Advert No. T10/2011 – Tender for the Procurement of the Main Ventilation Plant serving Hexagon House in Marsa

Advert No. T11/2011 – Tender for the Procurement of the Thermal plant for the Ventilation system serving Hexagon House in Marsa

CLARIFICATION 1

ROOF PLAN

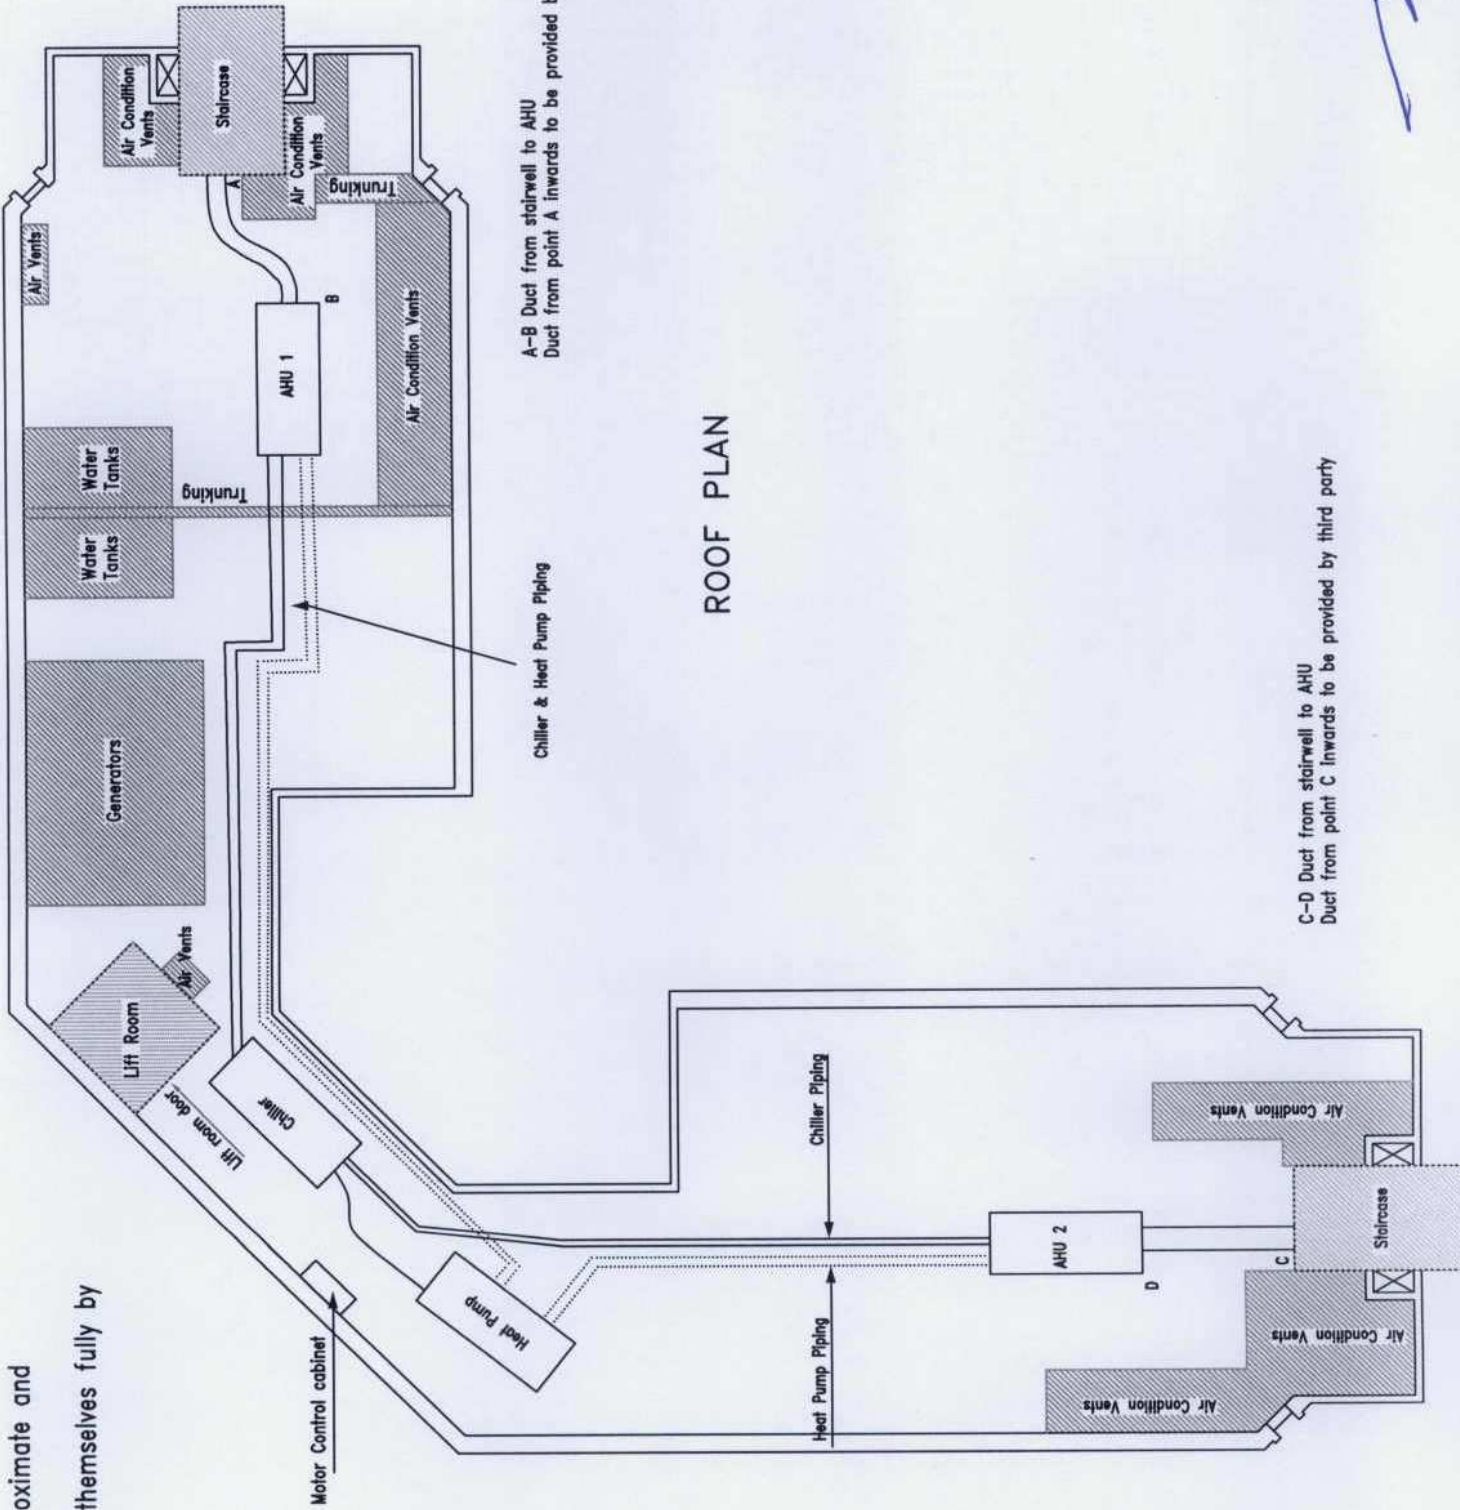
With reference to the position of the equipment and length of pipe work, ductwork and any related cables can you please specify if the location of the equipment is determined? Also is it possible that all tenderers will be informed about the total length of pipe work, ductwork and other material that shall be quoted so that all the tender offers will be based and compared on the same quantities.

The attached drawing shows approximate locations of the main equipment forming part of the tender. The tenderers must however ascertain the correct positioning depending on the physical size and the appropriate service space needed by the equipment that he is offering. The ducting

and pipework systems are to include all necessary straight duct lengths necessary for the correct operation of the plant and to achieve the minimum distances required between outdoor air intake points and building air exhaust points. We recommend that a site visit is carried out where the location of the offered equipment is established and the weights of the equipment are approved by a structural engineer.

Locations are approximate and indicative. Bidders to inform themselves fully by visiting site.
